ATTACHMENT 1 TO AEP:NRG:1146
10 CFR 50.92 ANALYSIS FOR CHANGES TO
THE DONALD C. COOK NUCLEAR PLANT
UNITS 1 AND 2
TECHNICAL SPECIFICATIONS

EXISTING TECHNICAL SPECIFICATIONS
PAGES MARKED TO REFLECT PROPOSED CHANGES

PROPOSED REVISED TECHNICAL SPECIFICATION PAGES

Figure 5.6-1: Donald C. Cook Nuclear Plant Schematic for Fuel Storage Racks Interface Boundary Between Regions 1 and 2

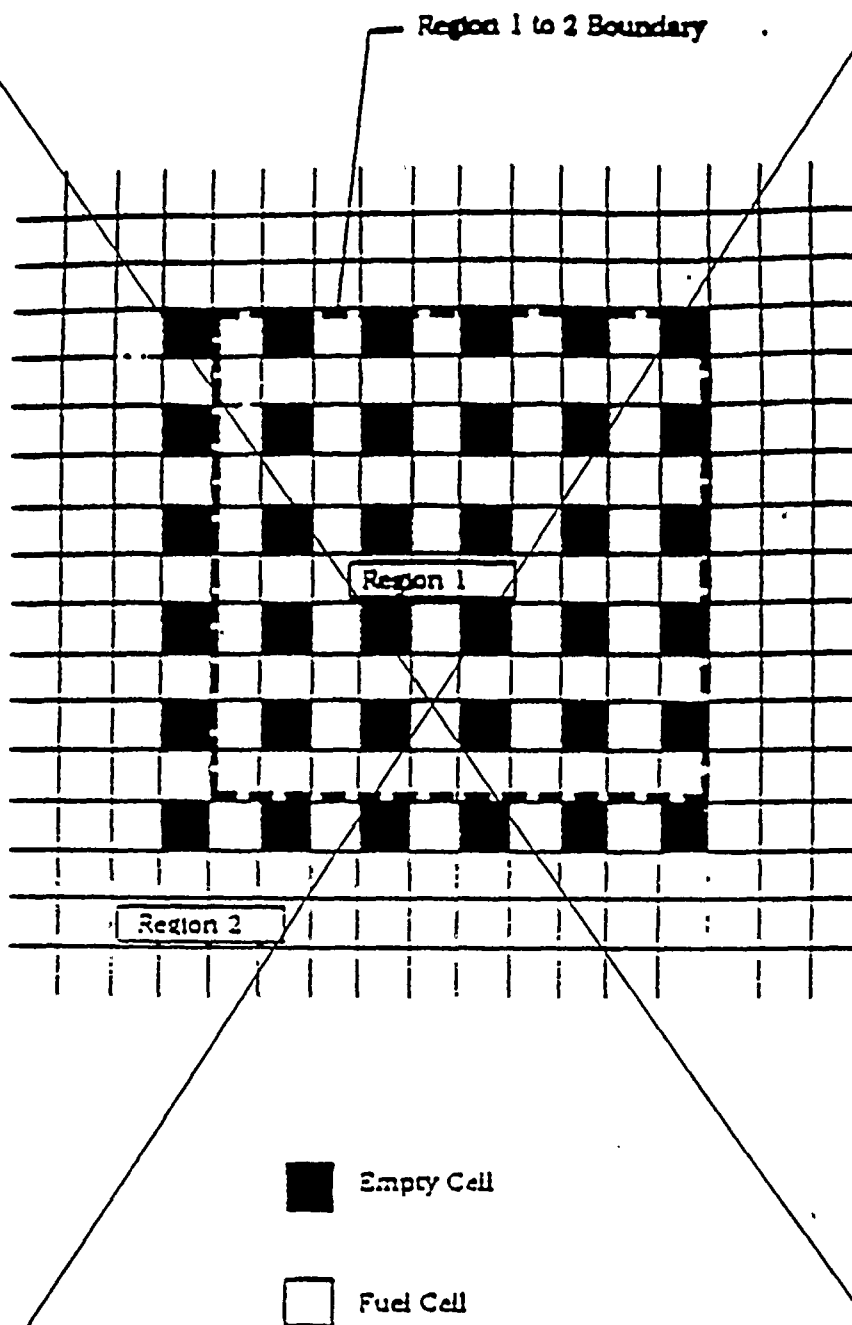
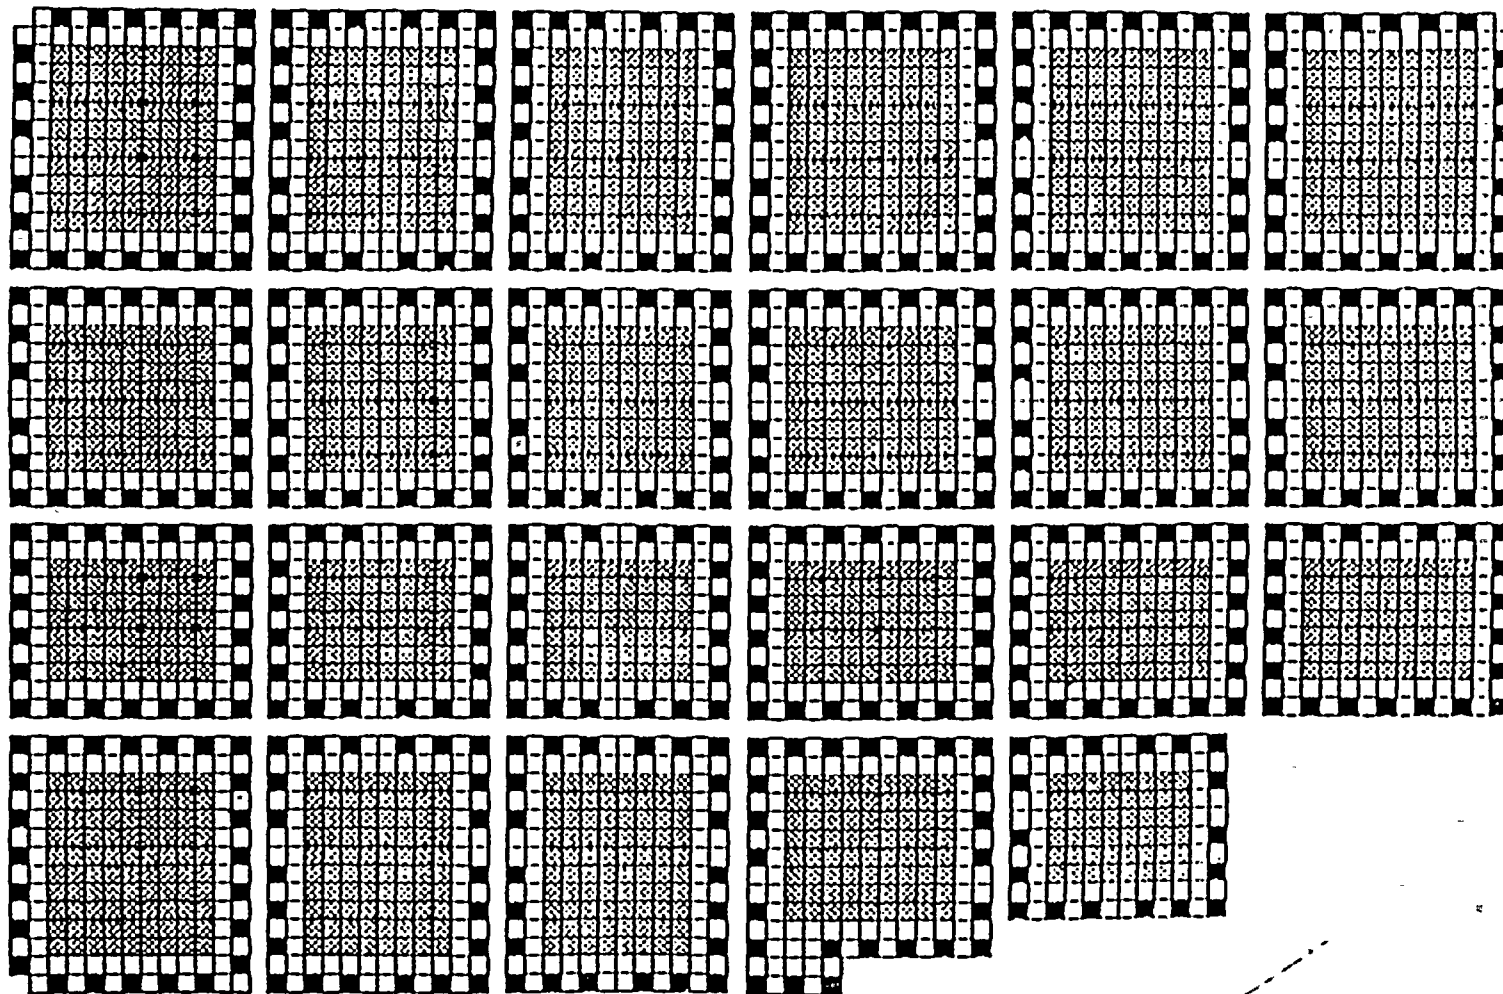
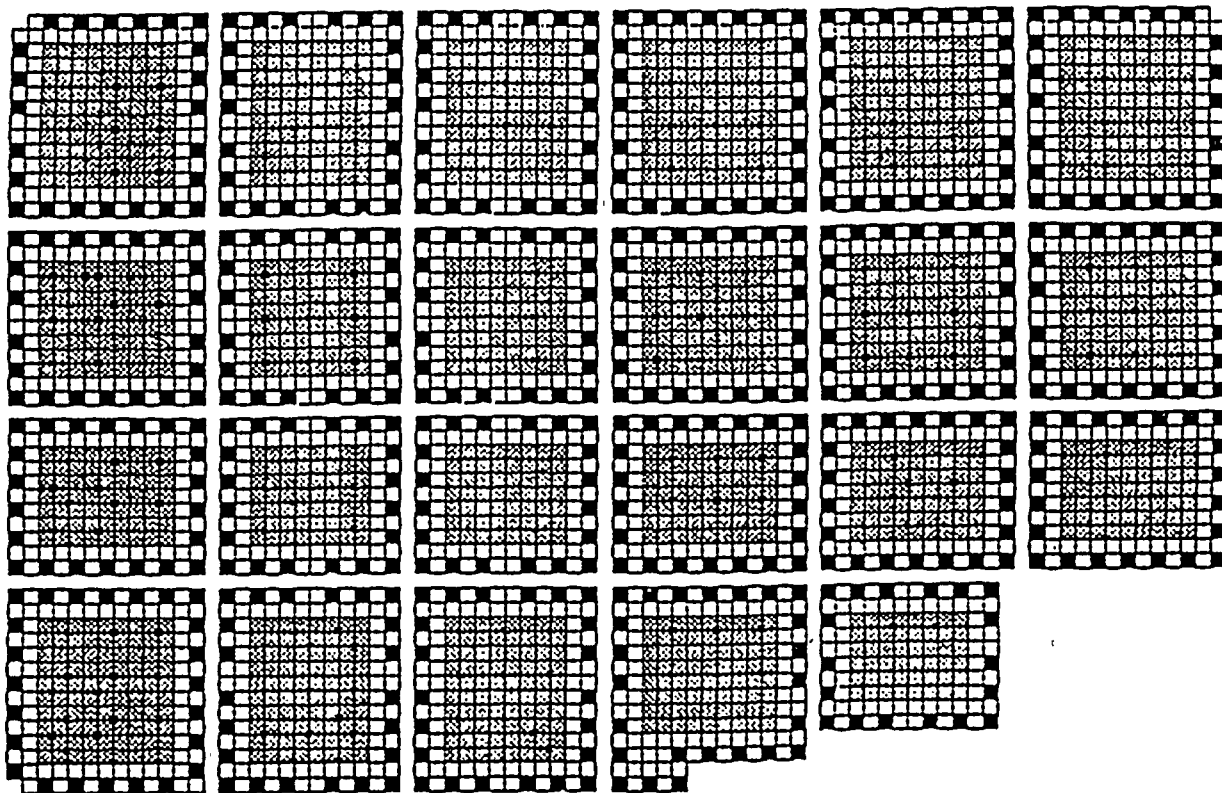
- a. A K_{eff} equivalent to less than 0.95 when flooded with unborated water.
- b. A nominal ~~10.5~~ ^{8.97}-inch center-to-center distance between fuel assemblies, placed in the storage racks.
- c. ~~1. A separate region within the spent fuel storage racks (defined as Region 1) shall be established for storage of Westinghouse fuel with nominal enrichment above 3.95 weight percent U-235 and with burnup less than 5,550 MWD/MTU. In Region 1, fuel shall be stored in a three-out-of-four cell configuration with one symmetric cell location of each 2 x 2 cell array vacant.~~
~~2. The boundary between the Region 1 mentioned above and the rest of the spent fuel storage racks (defined as Region 2) shall be such that the three-out-of-four storage requirement shall be carried into Region 2 by at least one row as shown in Figure 5.6-1.~~

FIGURE 5.6-1: Normal Storage Pattern (Mixed Three Zone)

Figure 5.6-2 - A.

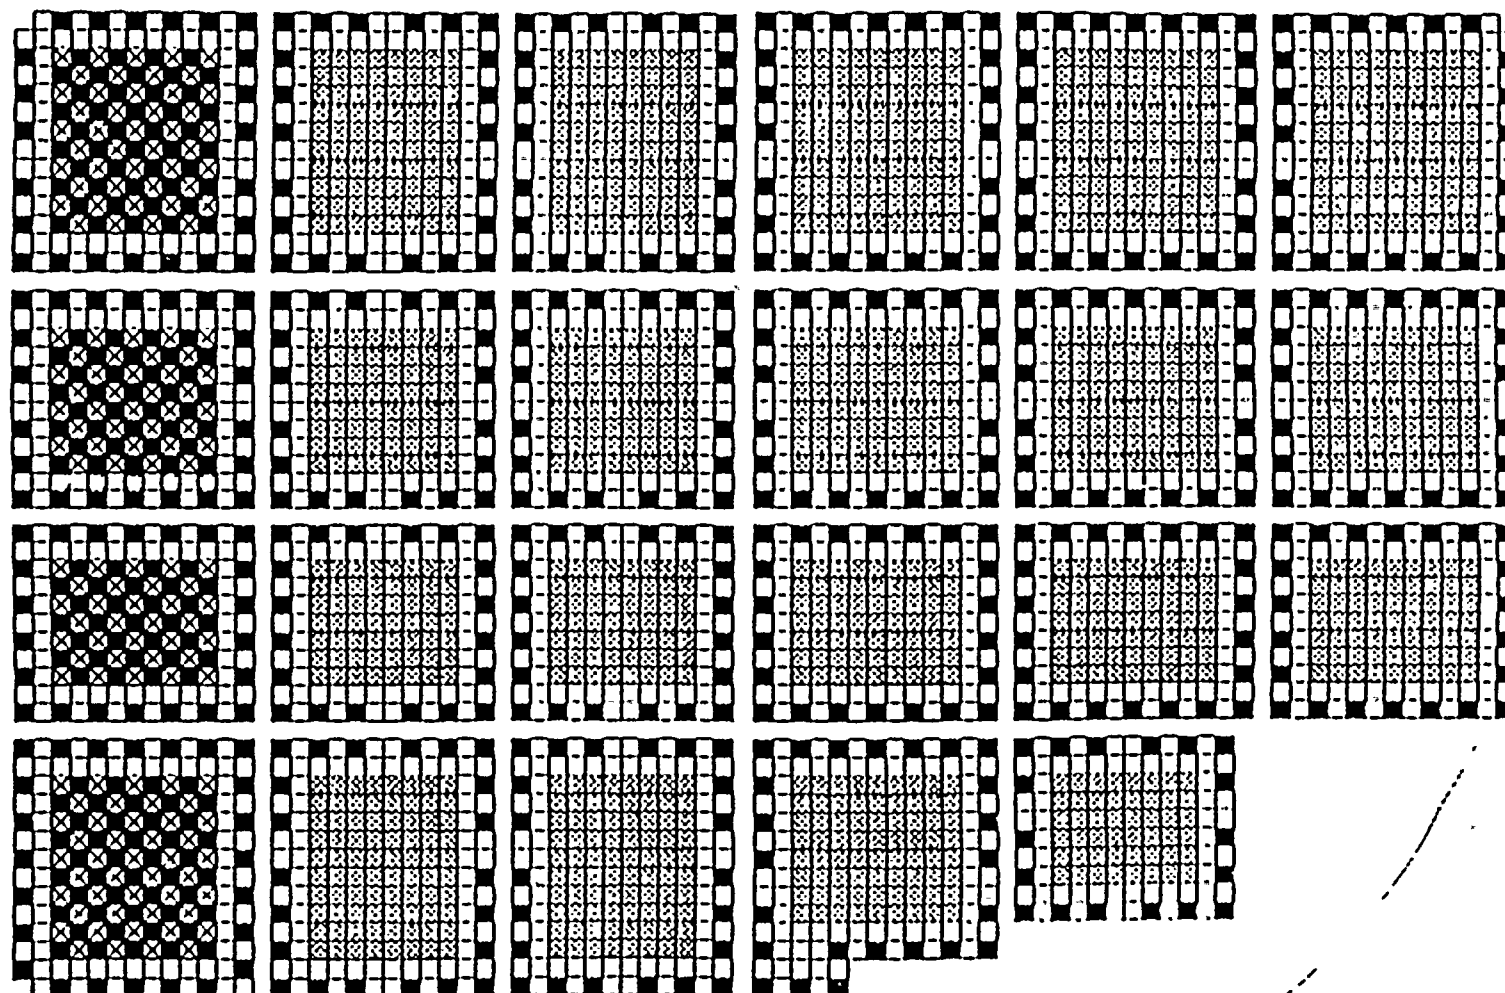
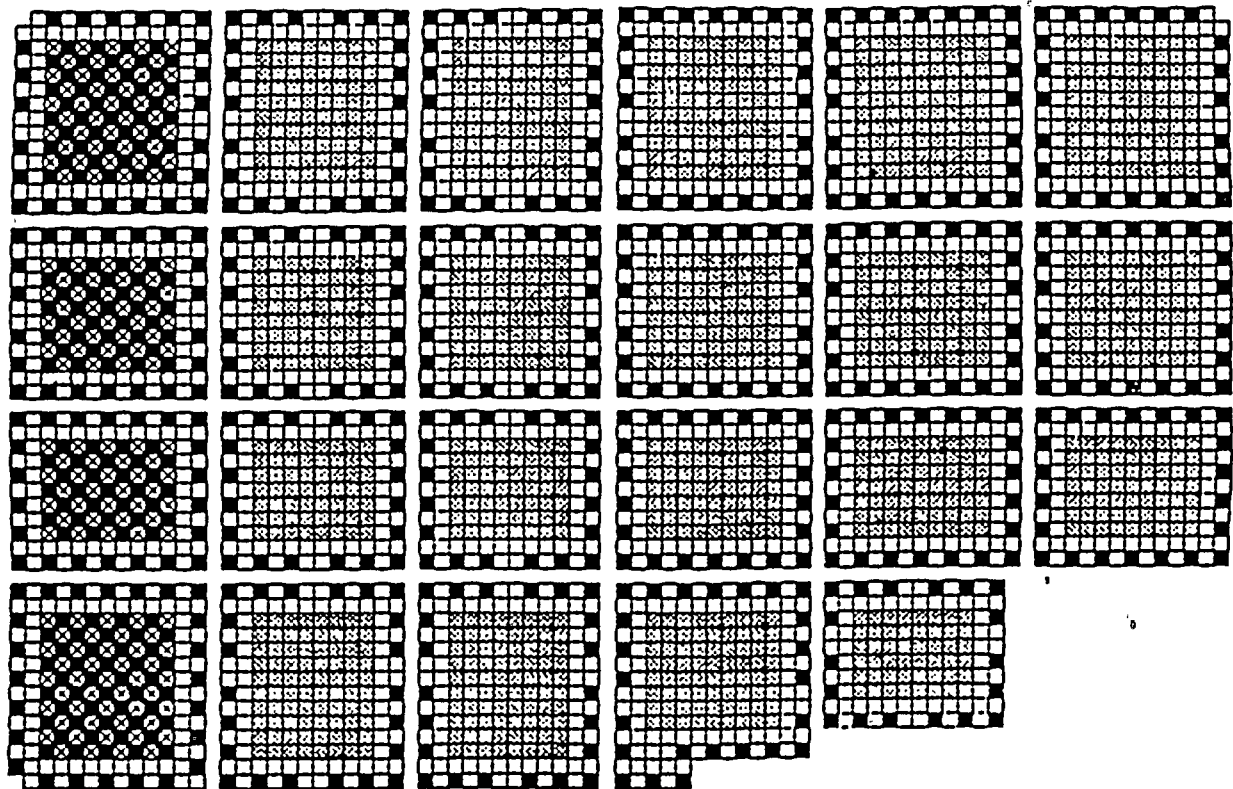
- #1. Region 1 ^{nominal} is designed to accommodate new fuel with a maximum enrichment of 4.95 wt% U-235, or spent fuel regardless of the discharge fuel burnup.
- #2. Region 2 ^{nominal} is designed to accommodate fuel of 4.95% initial enrichment burned to at least 50,000 MWD/MtU, or fuel of other enrichments with equivalent reactivity.
- #3. Region 3 ^{nominal} is designed to accommodate fuel of 4.95% initial enrichment burned to at least 38,000 MWD/MtU, or fuel of other enrichments with equivalent reactivity.

Figure 5.6-2: Interim Storage Pattern (Checkerboard)

Fig. 4-3 ACCEPTABLE BURNUP DOMAIN IN REGIONS 2 & 3

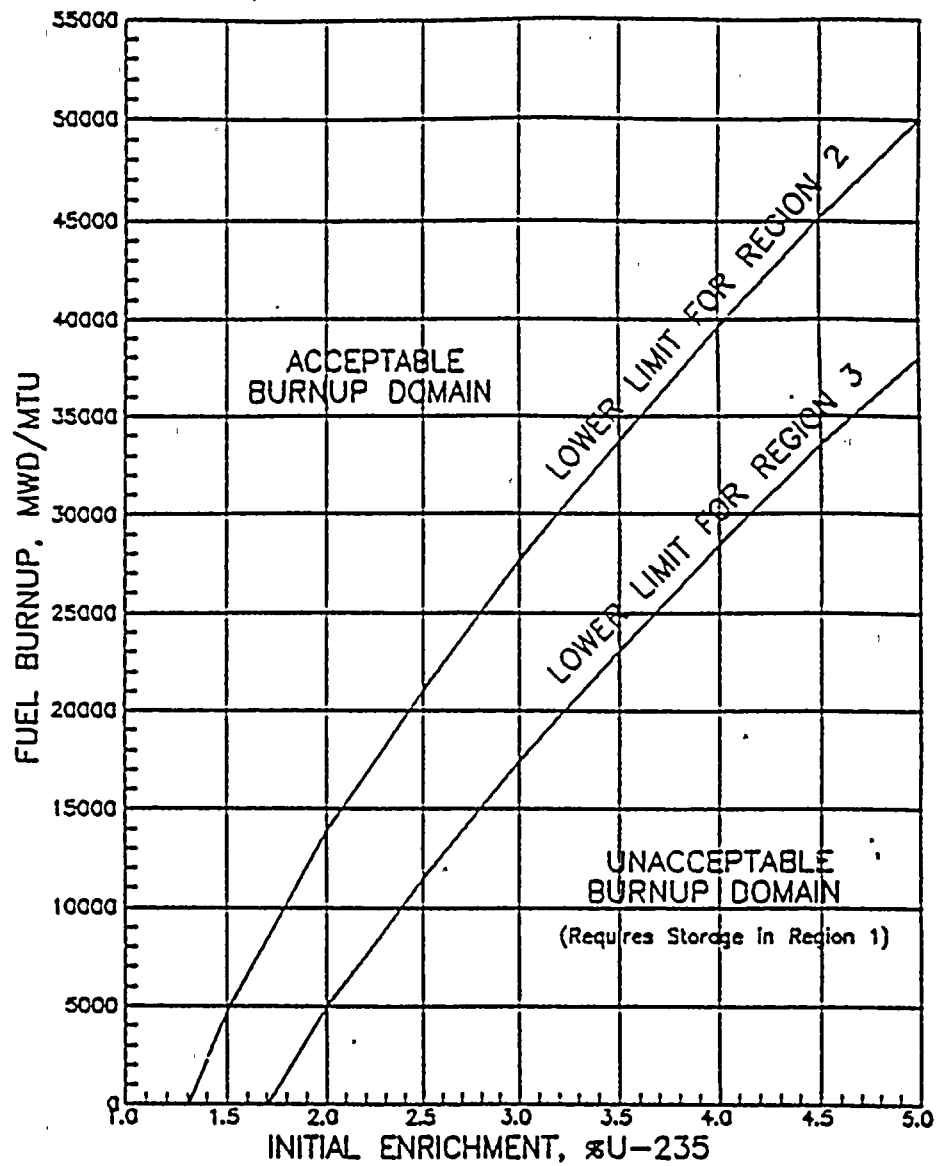
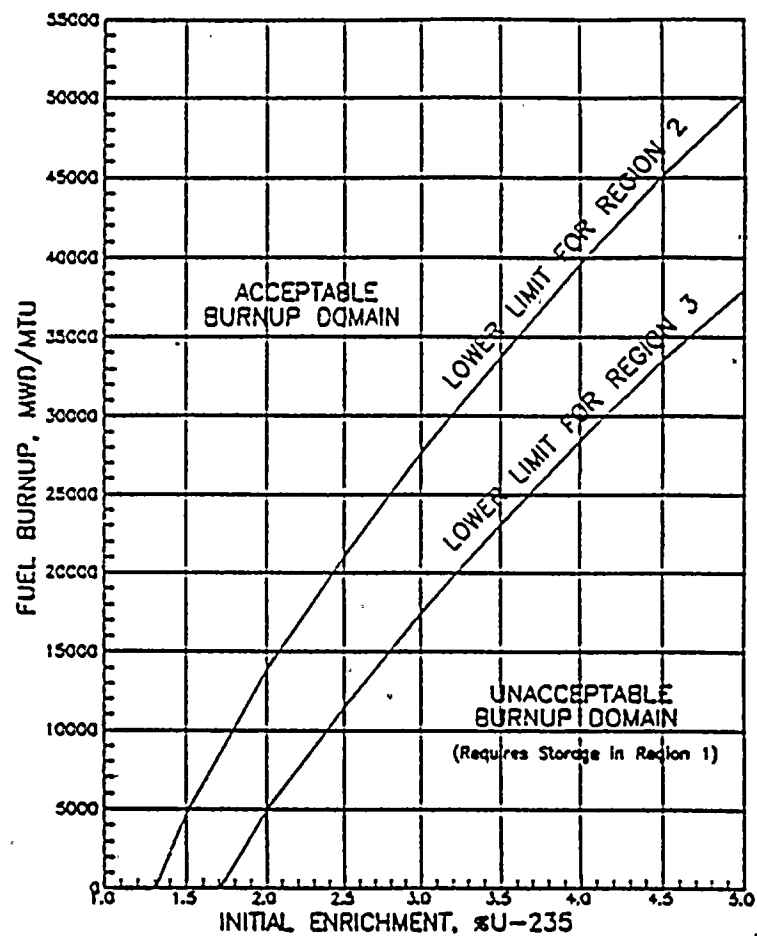
The equivalent reactivity criteria for Region 2 and Region 3 is defined via the following equations and ~~are~~ graphically depicted in Figure 5.6-3.

Figure S.6-3: Acceptable Burnup Domain in Regions 2 & 3
